UNITED STATES ENVIRONMENTAL PROTECTION AGENCY
RESEARCH TRIANGLE PARK, NC 27711

MEMORANDUM

SUBJECT: Model Clearinghouse Review of Use of Non-default Radius for Determining Surface Roughness Length for AERMET

SUBJECT: Kentucky NewGas Project – Site-Specific, Non-Default Radius for Roughness Determination

Figure 1. Surface Roughness Estimates by Sector for BWG Airport - AERSURFACE vs. GFM

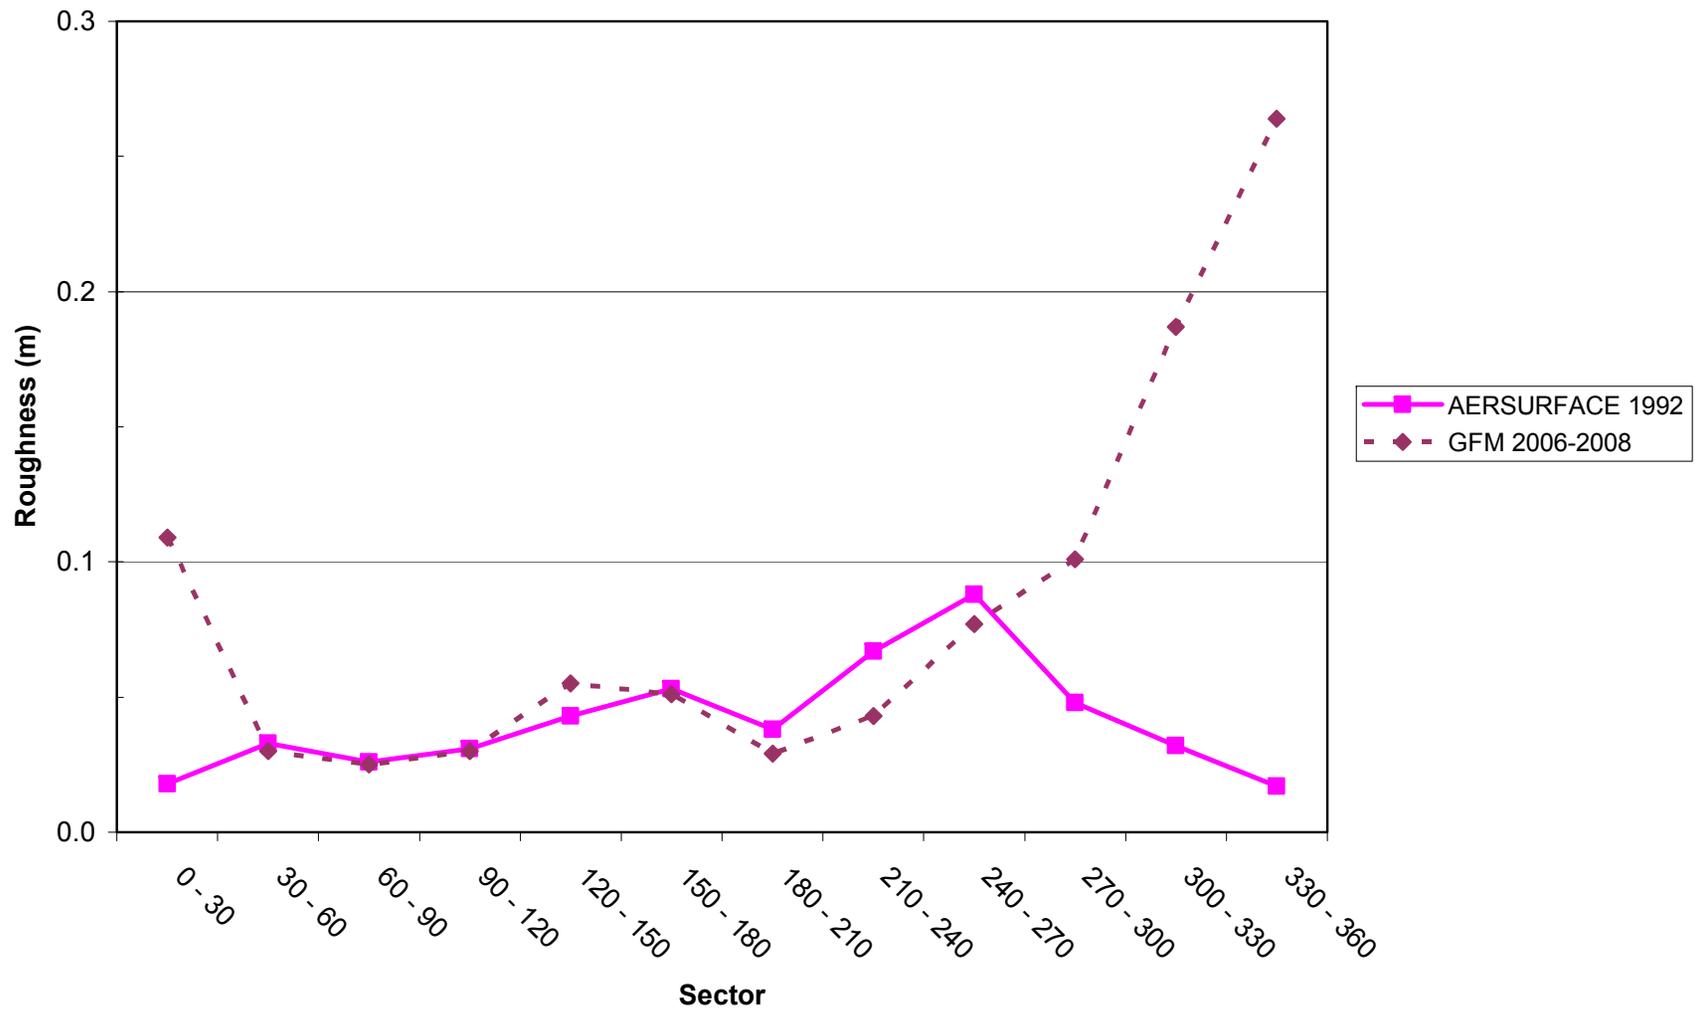
As part of our review of the Region 4 request, we have also applied the GFM to estimate surface roughness for the BWG site, using available 1-minute ASOS wind data for 2006 through 2008. The results of this test, presented in Figure 1, show generally good agreement between AERSURFACE estimates using the default 1 kilometer radius and GFM estimates across most sectors. The AERSURFACE roughness estimates are slightly higher than the GFM estimates for the 240°-270° sector highlighted in the Region 4 memorandum as showing a significant increase in roughness with increasing radius. However, significant differences between the AERSURFACE and GFM estimates are found for the WNW through N sectors, with higher roughness estimates based on the GFM than AERSURFACE. These differences appear to be attributable to a significant change in land cover for those sectors for the 2006-2008 period used in the GFM compared to the 1992 NLCD used in AERSURFACE. A review of the aerial photo provided with the Region 4 request taken in March 1993 shows indications of a golf course under construction in very close proximity to the meteorological tower (within about 50 meters). More recent aerial photos show the completed golf course surrounding a residential community and other commercial buildings. Figure 2 provides an aerial photo of the site from 2008. The proximity of this change in land cover to the meteorological tower contributes to the significantly higher roughness values for those sectors based on the GFM than estimated by AERSURFACE based on 1992 NLCD, which depicts the area as “Urban/Recreational Grasses”.

These comparisons of roughness estimates for BWG based on AERSURFACE and the GFM provide some objective support for the Model Clearinghouse response to the Region 4 request regarding use of a non-default radius for estimating surface roughness values for use in processing the BWG meteorological data. They also illustrate the importance of assessing the temporal representativeness of the land cover data for the meteorological data period being processed. In this case, use of AERSURFACE roughness estimates with recent meteorological data for BWG (later than about 2000) could significantly underestimate the surface roughness for the WNW through N sectors. We would recommend adjusting the surface roughness values estimated by AERSURFACE based on these GFM results for upwind sectors between about 270° and 30° when processing BWG data for recent years, while using AERSURFACE estimates based on the default 1 kilometer radius for other sectors.

FIGURE D-5. LANDUSE AND LAND COVER SURROUNDING THE PROPOSED KENTUCKY NEWGAS FACILITY

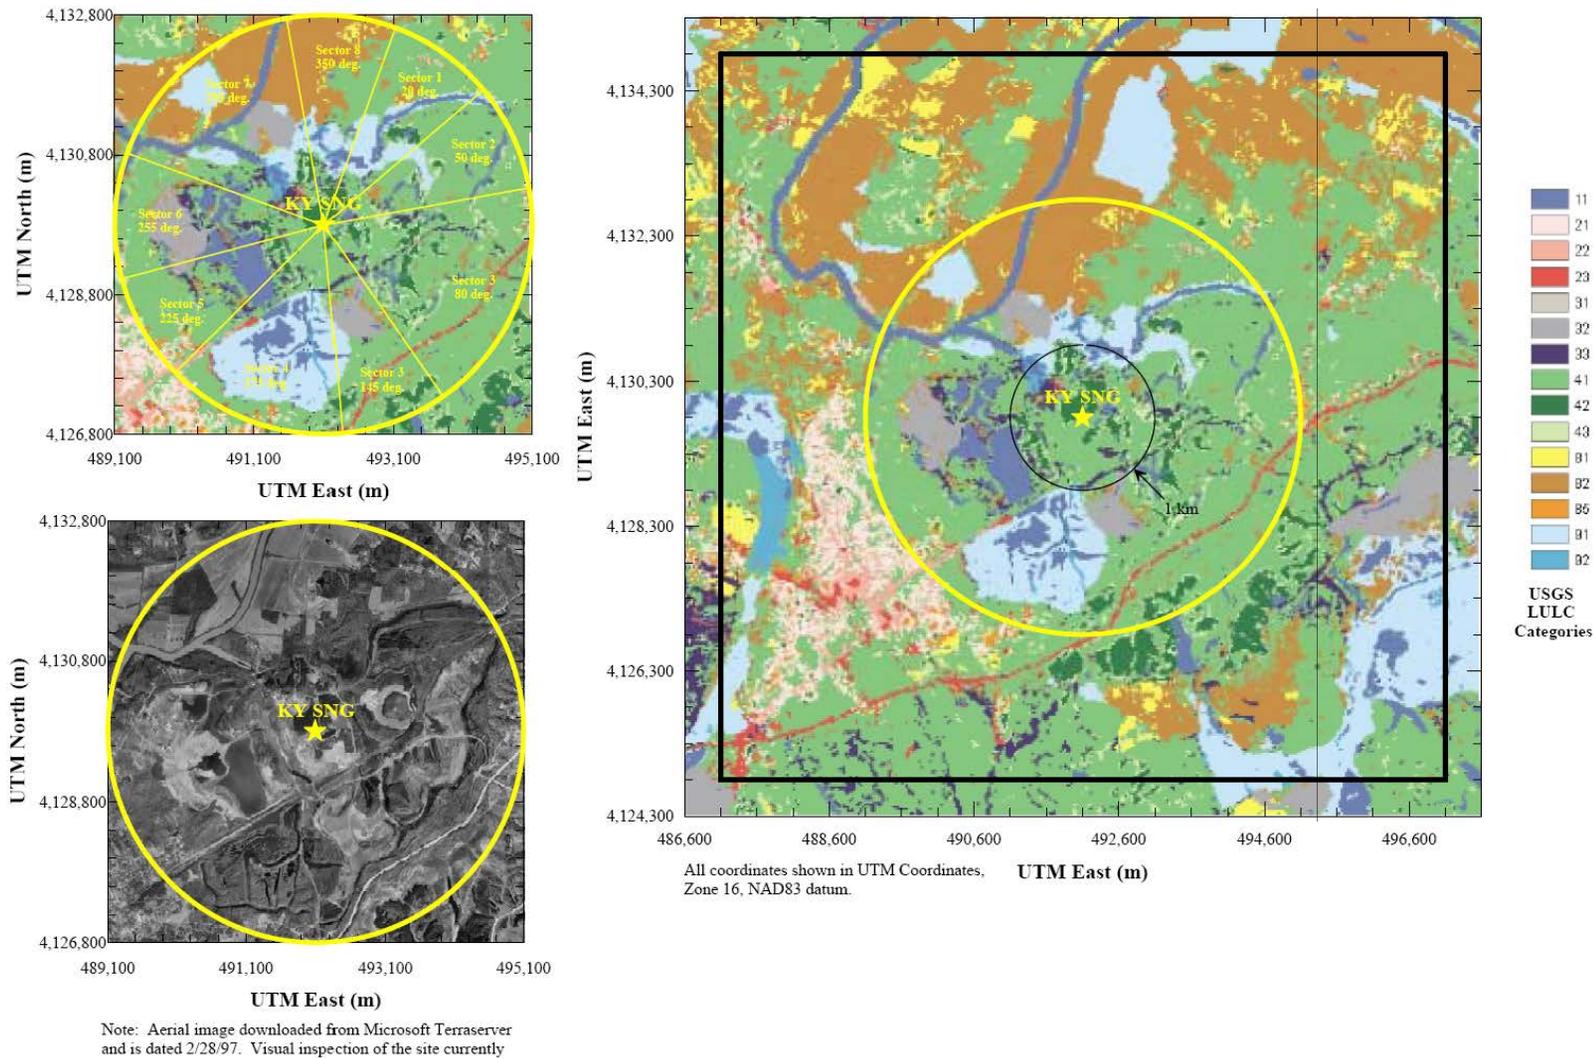
In a Prevention of Significant Deterioration (PSD) application for the proposed KYNG facility, they state that the land cover figures (Attachment 1 - Figure D-5, and Attachment 2 – Figure D-6) show significant discontinuities in the land use surrounding the Bowling Green NWS (BWG) site, the source of the meteorological measurements used in the air quality impact modeling, and the project location just beyond the 1 km recommended radius justifying the use of larger site-specific radii for these locations.

Review of the land cover for KYNG site in Figure D-5 reveals land cover changes just beyond 1 km (i.e., between 1.0 and 1.5 km). The changes occur in the northeast, southeast, southwest, and northwest directions from the proposed project location. The BWG site in Figure D-6 also reveals land cover changes just beyond the 1 km radius (i.e., between 1.0 and 1.5 km) to the west, northwest, and north of the tower. The expected

FIGURE D-6. LANDUSE AND LAND COVER SURROUNDING THE BWG AIRPORT

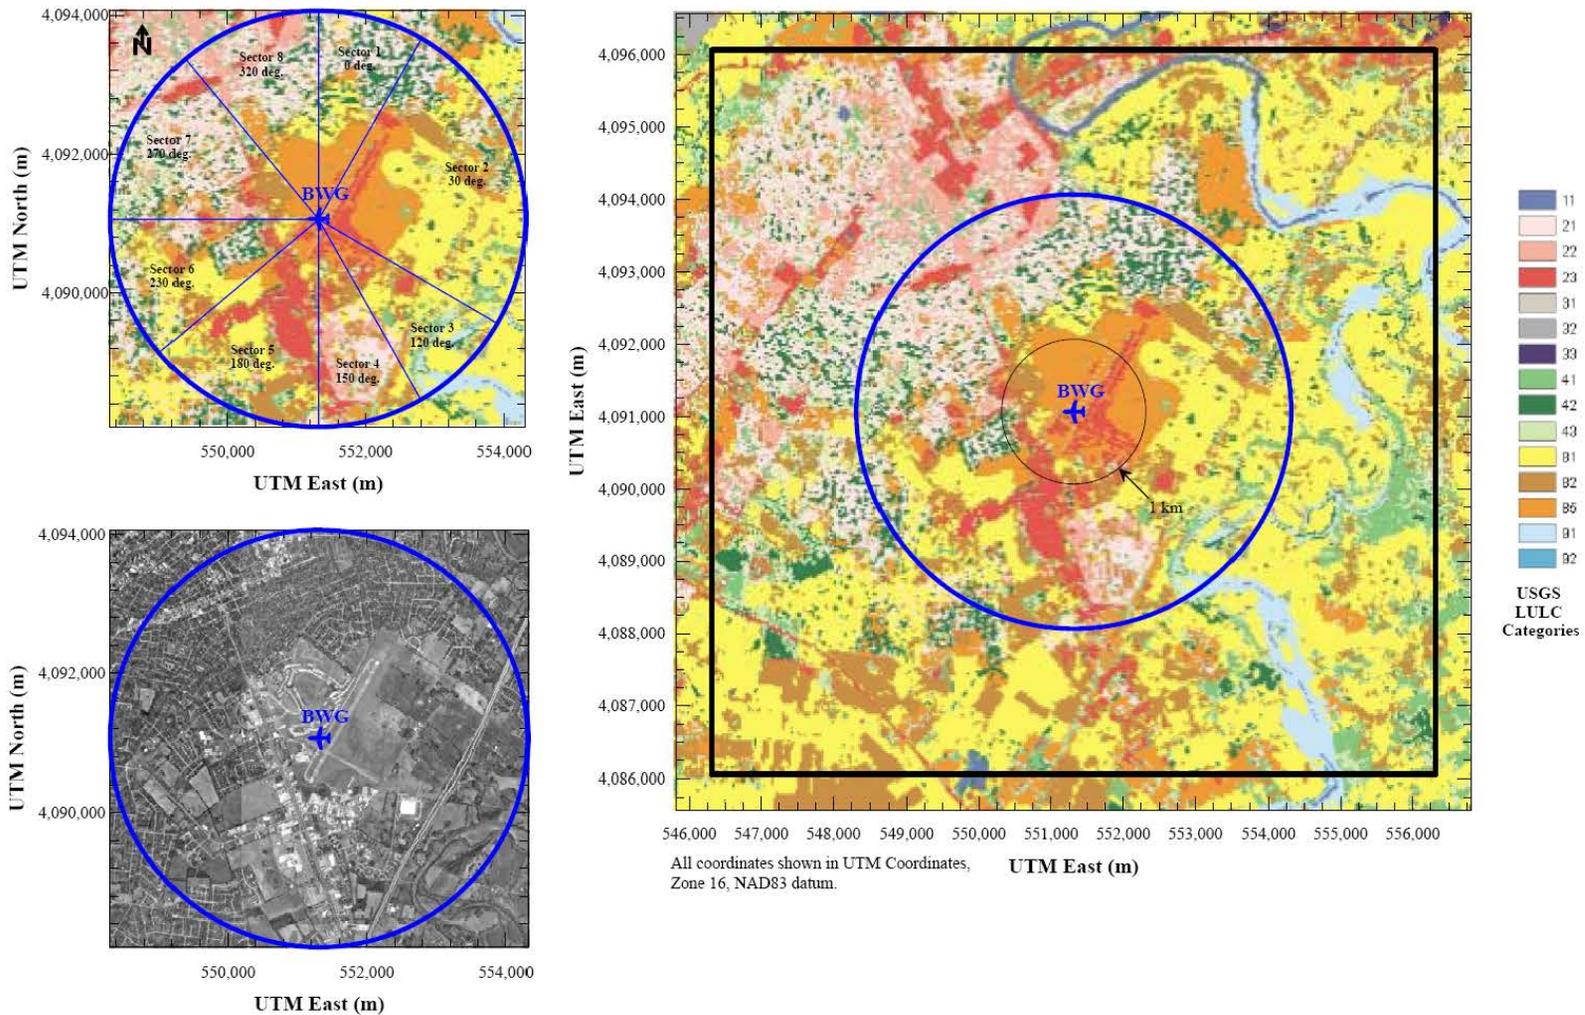
magnitude of the roughness changes associated with these land cover changes cannot easily be determined from these figures. The magnitudes of the change in roughness are implicitly included in the results of the iterative radius AERSURFACE runs.
